C-900 - ADDENDUM

Addendum No. 2

Date:	<u>March 27, 2019</u>
Issued To:	<u>Plan Holders</u>
From:	<u>Alan Plummer Associates</u>
Project:	<u>Wastewater Treatment Plant Expansion</u>

Village of Taos Ski Valley Wastewater Treatment Plant Expansion Pre-Bid Meeting Agenda March 18, 2019 – 1:00 PM

PREANOXIC BASIN P&ID

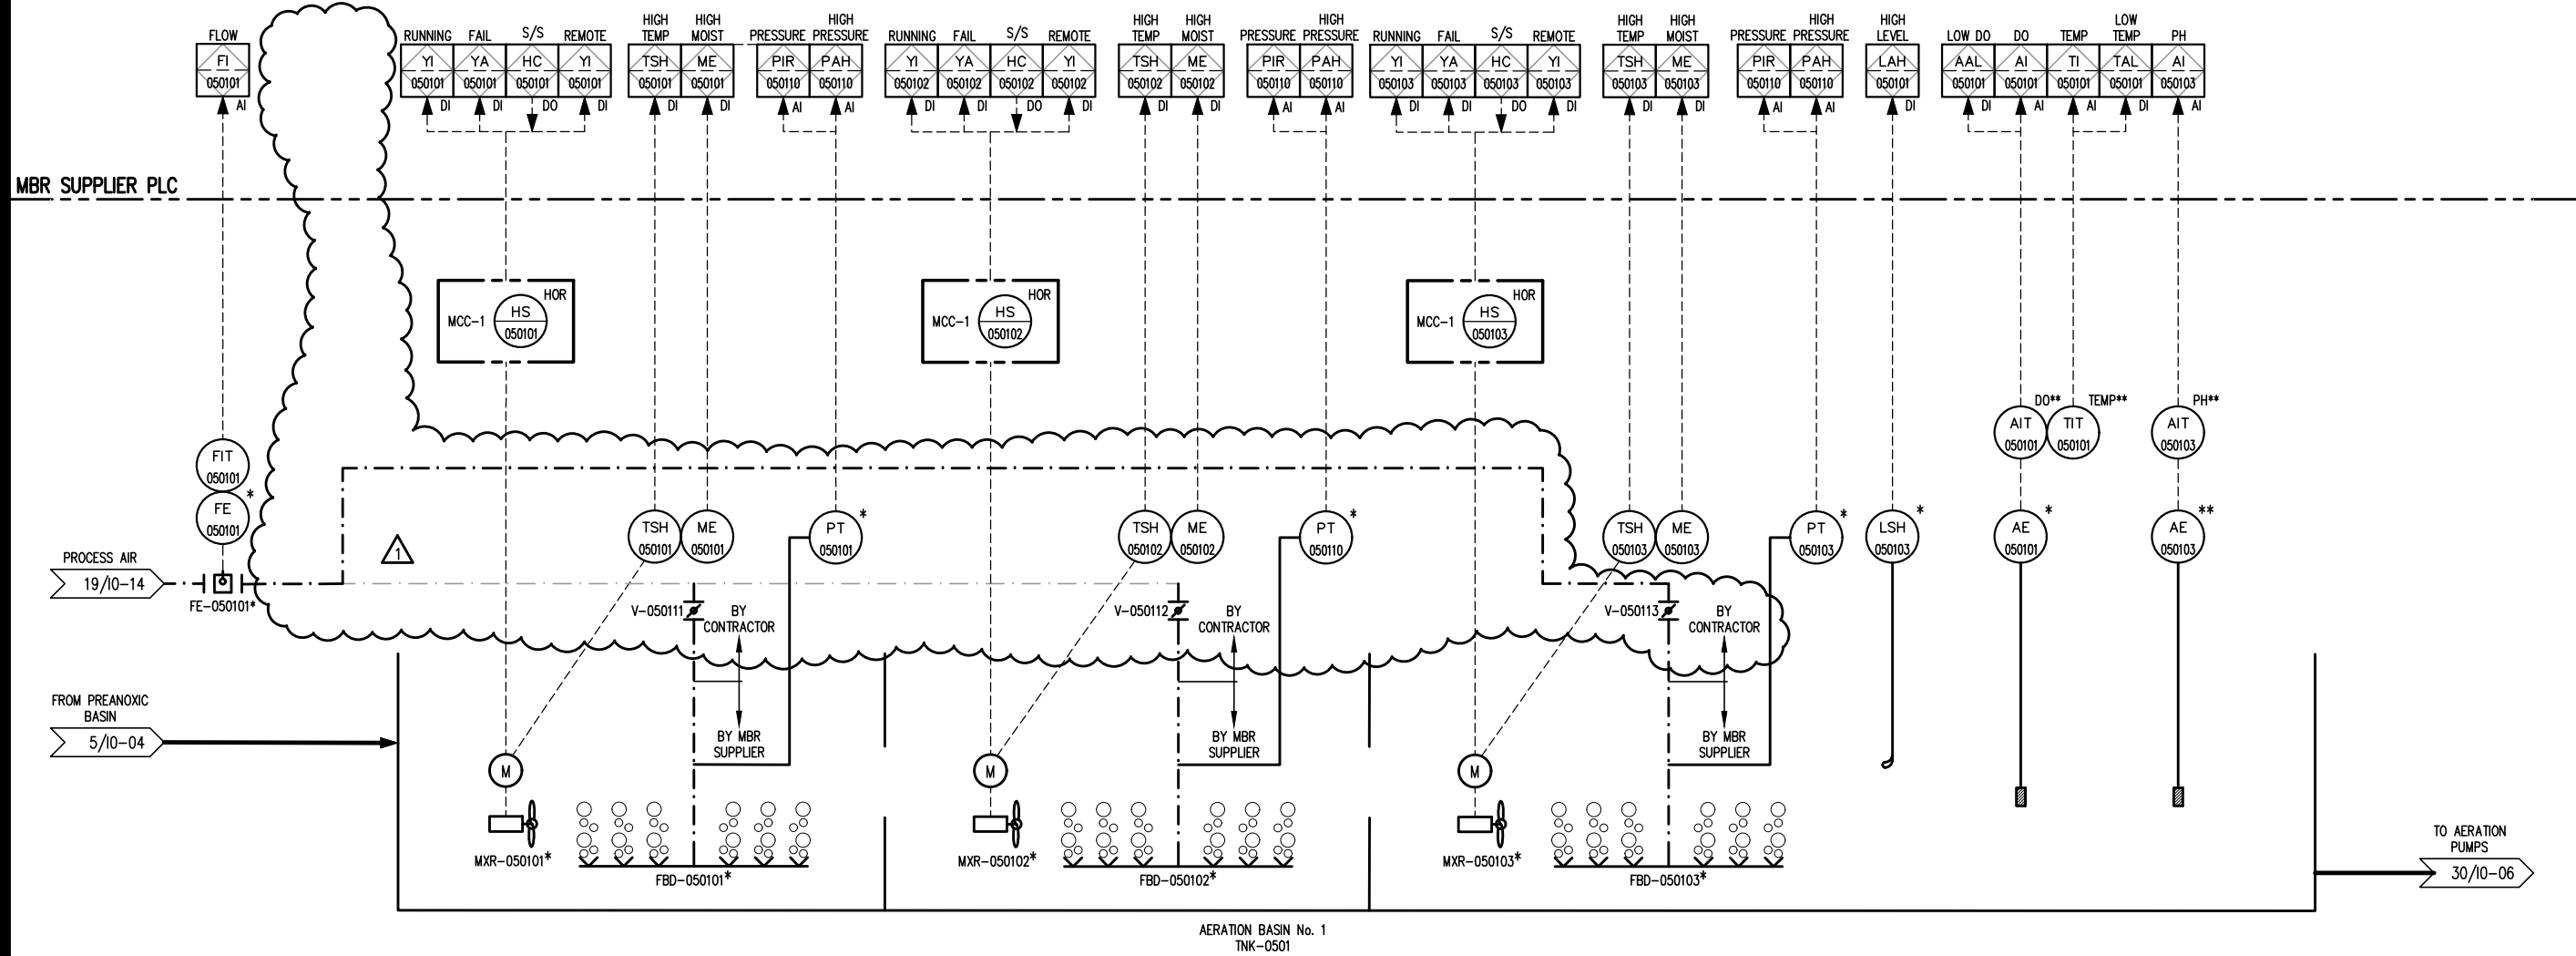
1. Response: Refer to revised Sheet No.'s I0-11 and I0-12 included in this Addendum.
- F. Plan Sheet P1-04 & P3-04: Both dwgs show an 8" Flow Meter on what becomes the 14" RAS Line. Does this Flow Element appear in the P&IDs? It appears that this Line is represented in the P&IDs on sht I0-11 and I0-12 and continued @ 18/I0-04 & 22/I0-04, and no meter is shown on this line.

1. Response: Refer to revised Sheet No. I0-4 included in this Addendum.
- G. Plan Sheet P1-04 & P3-04: Both dwgs show 4" Plug Valves (note #4) and 4" Elec. actuated Plug Valves (note #6). What are these Valve Tag #s on the P&IDs? Are these valves provided by the MBR Supplier?

AERATION PUMPING

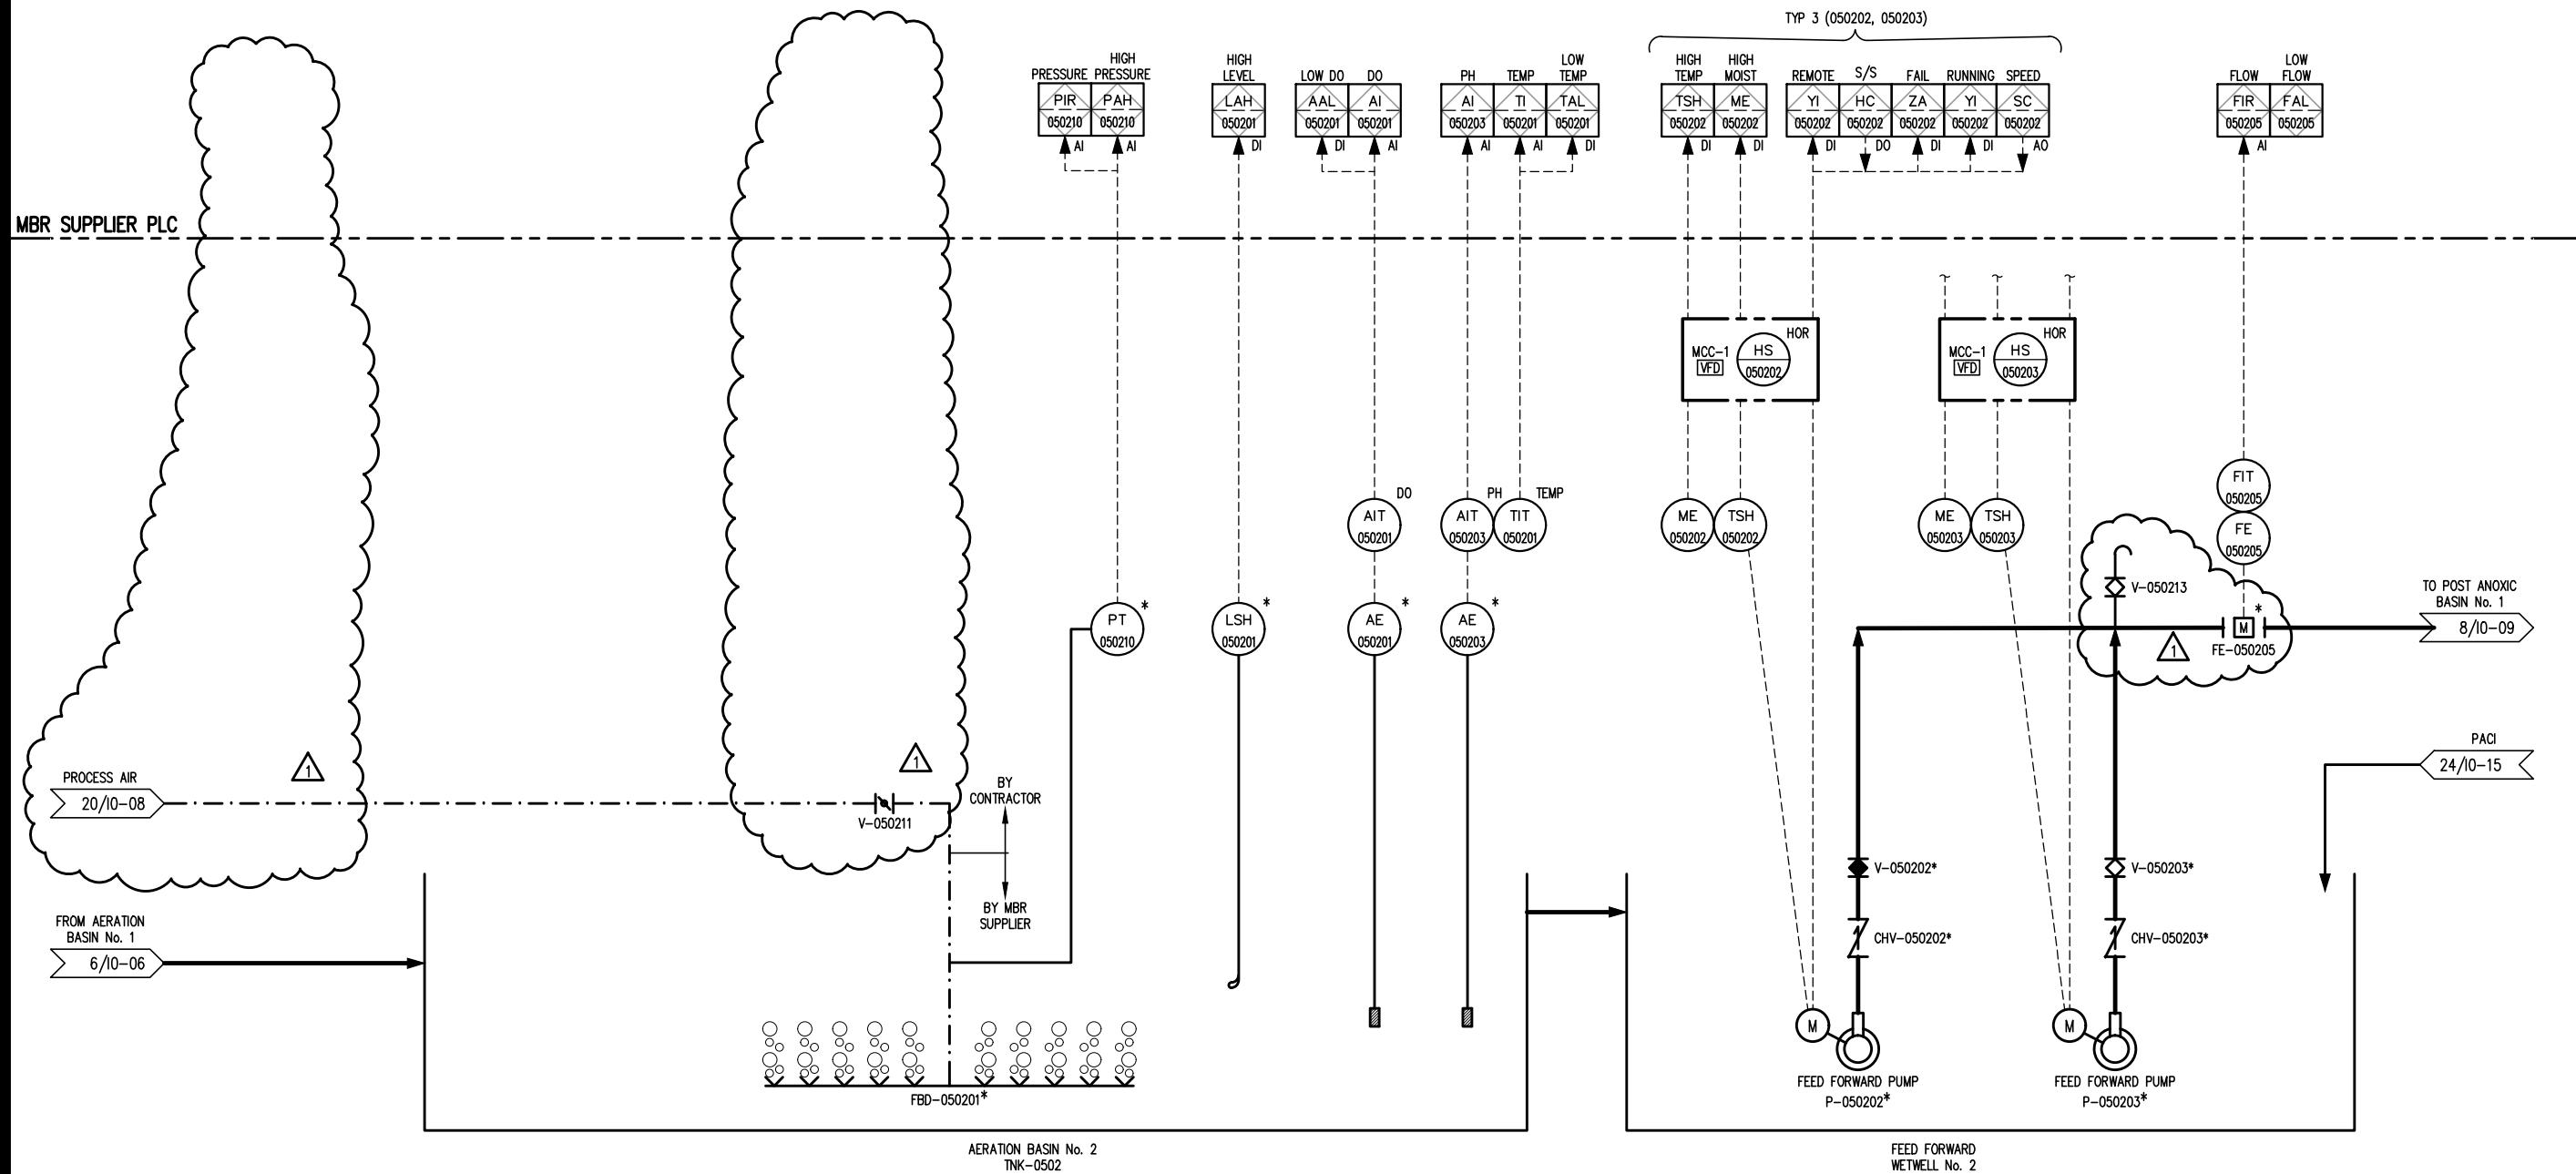
- A. Sheet IO-06 and Sheet P3-01; these sheets both show the Aeration Pump Discharge assembly. IO-06 shows 3 EA Check Valves and 5 EA Plug Valves, while P3-01 shows only 2 EA Check Valves and 4 EA Plug Valves. No Valves are shown (P3-01) on the discharge for the middle Pump (P-050105) Please Clarify.

- 1. Response: Refer to Sheet No. P3-01 and revised Sheet No. IO-06 included in this Addendum for the aeration pump discharge valve requirements.
- B. P sheets call for "Air Release Plug Valves" or "2" Plug Valve ARV", yet detail 9/P4-03 calls for a "Ball Valve w/ NPT Connections", furthermore Spec 15105, 2.11, D, 4 calls for Bronze Gate Valves as the Isolation Valves in the ARV Assembly. Please clarify what type of valve is to be used at these locations?

AERATION BASIN NO. 2 P&ID

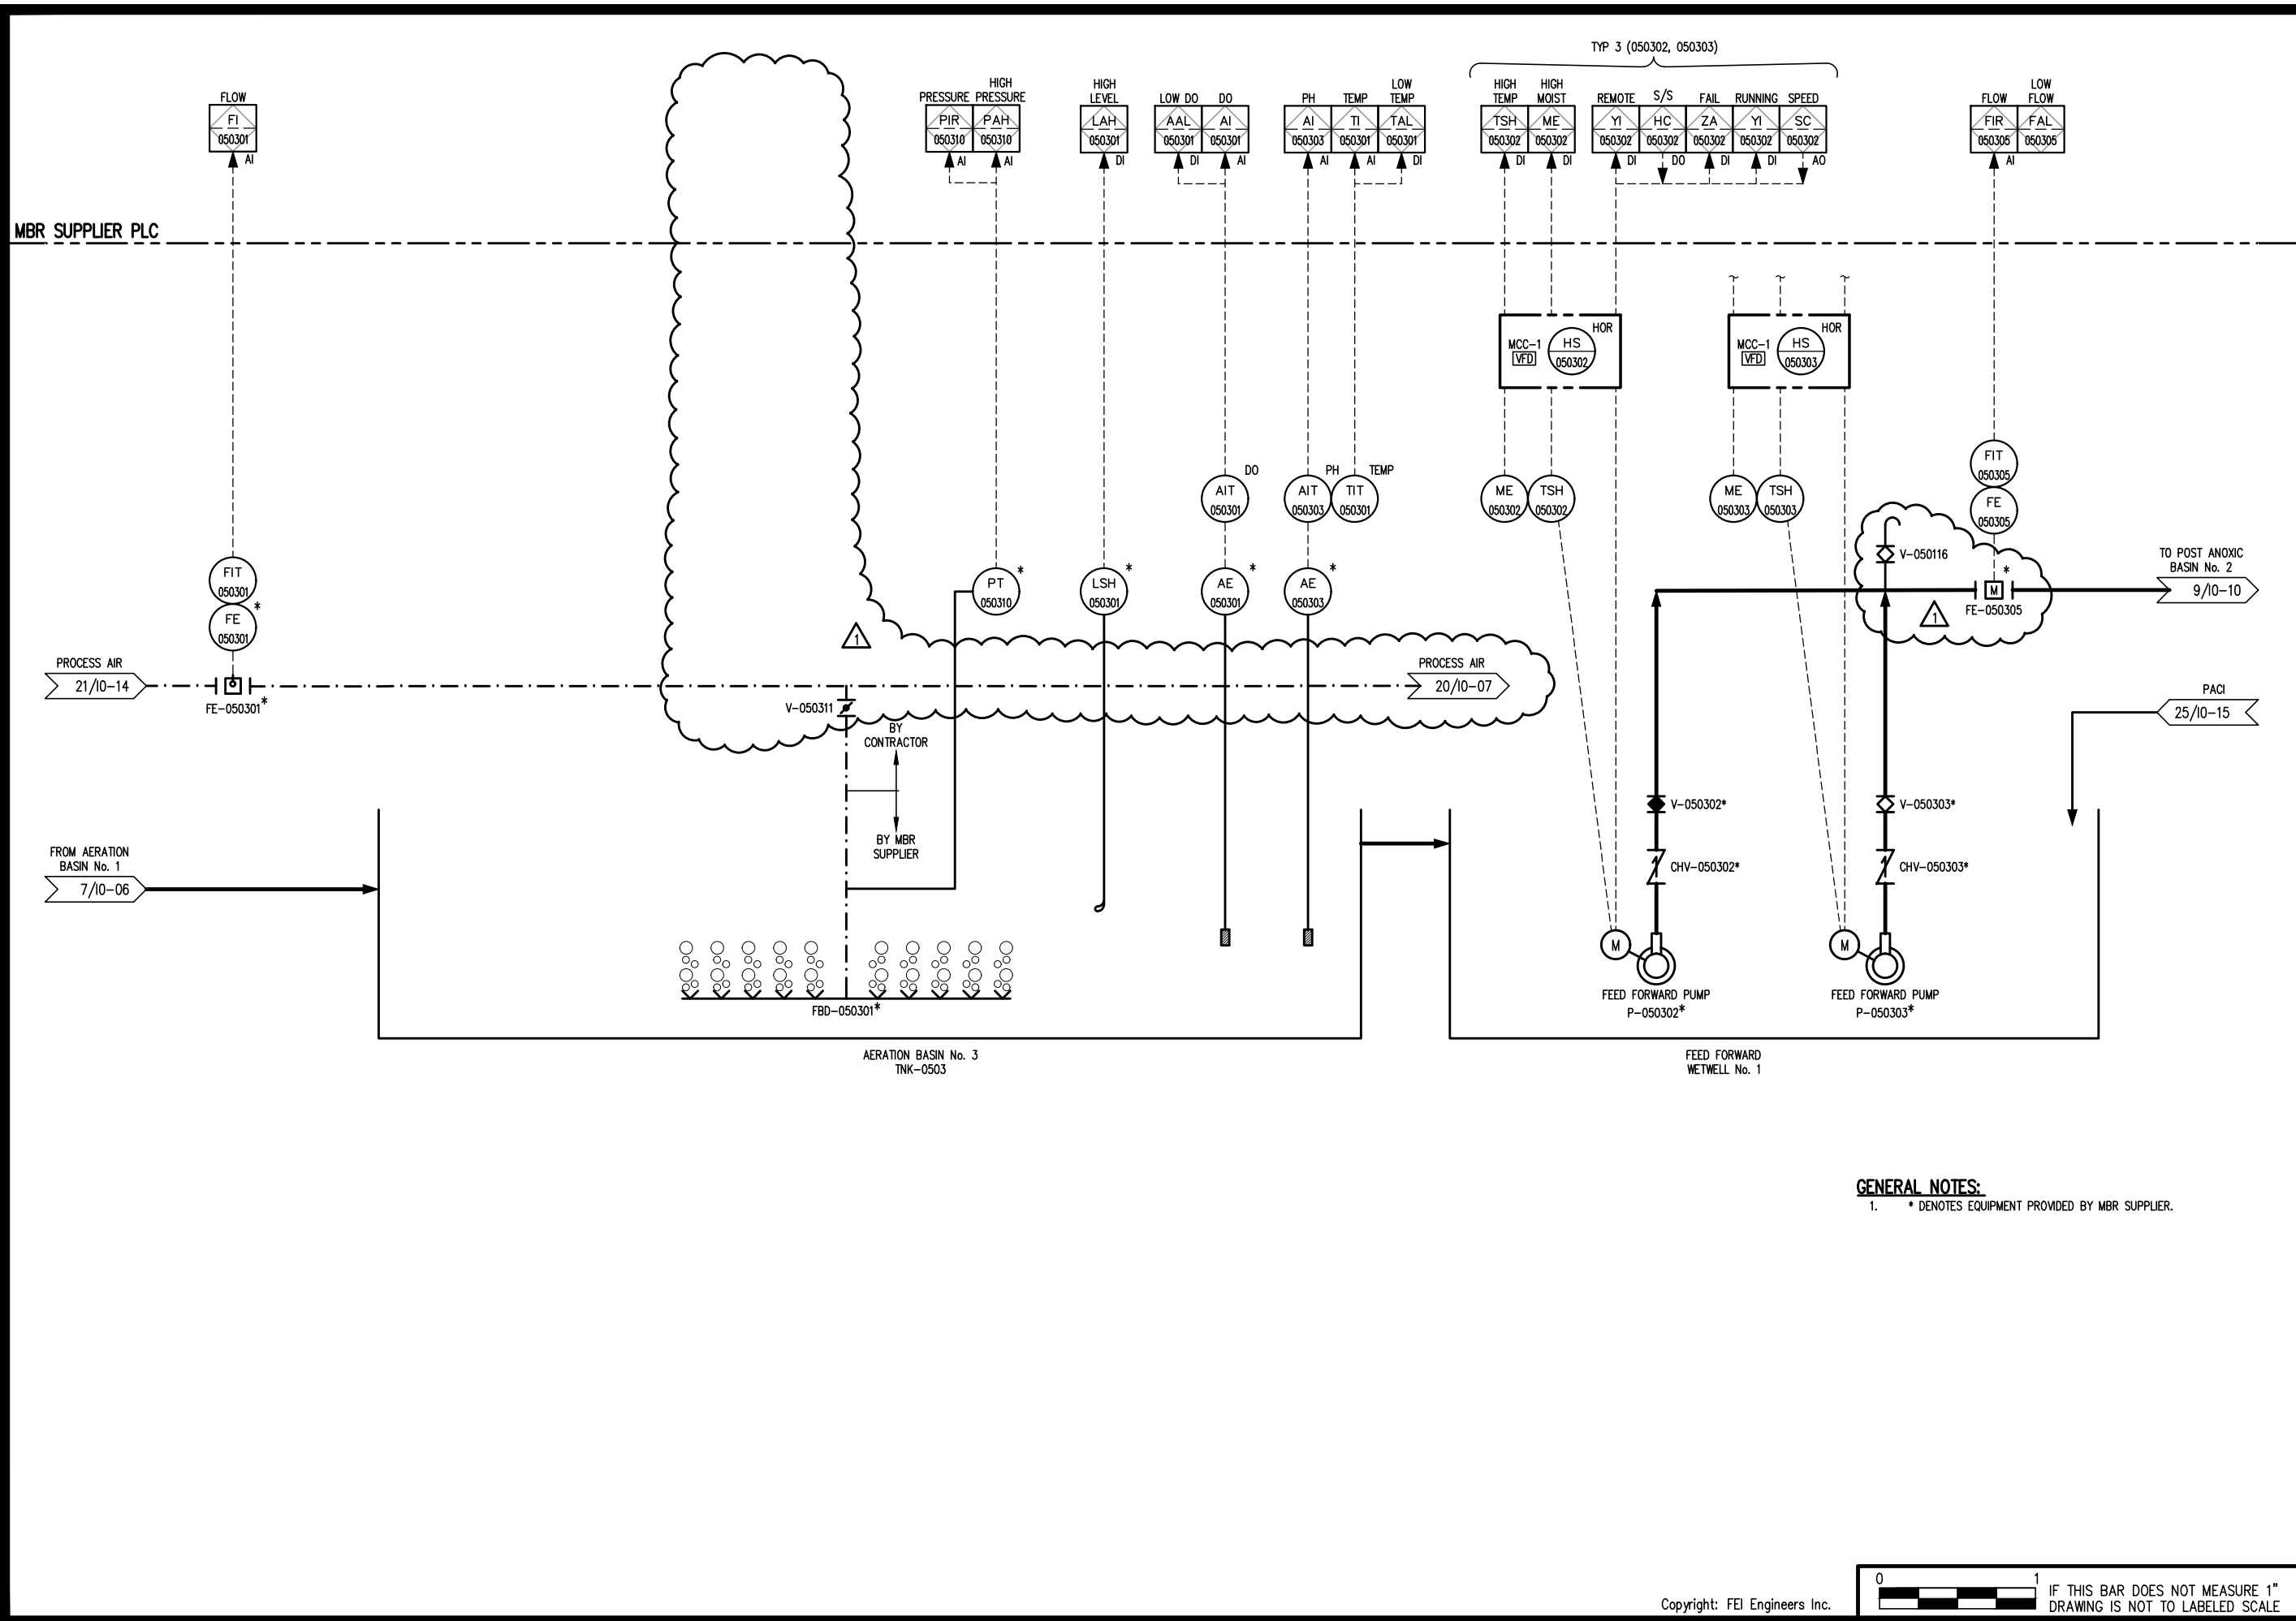
- M. Sheet P3-02, Note #17: Note calls for 4" BFV, What is this Valves Tag # on the P&IDs? Is this valve provided by the MBR Supplier?

1. Response: 4" BFV is not provided by the MBR Supplier. The valve tag for Aeration Basin No.2 is V-050211 and Aeration basin No.3 is V-050311, as shown on revised Sheet No.'s IO-07 and IO-08 included in this Addendum
